ADDENDUM No. 2

REQUEST FOR QUOTATIONS No.: 1220-040-2024-034

TITLE: SURREY SPORT AND LEISURE COMPLEX - CHILD MINDING PLAY SPACE AND MULTI-PURPOSE ROOM RENOVATION

ADDENDUM ISSUE DATE: OCTOBER 7, 2024

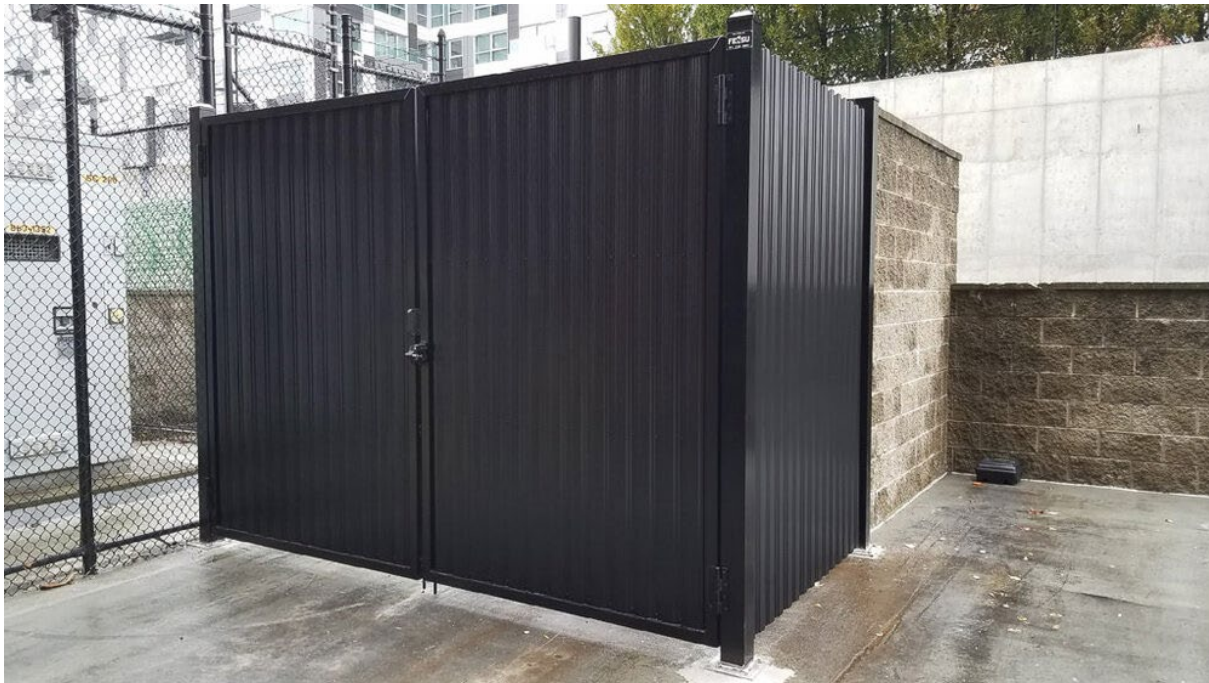
Q11. Could you please confirm that this type of fencing would be comparable to Superior's fencing?

A11. Yes, this is acceptable.
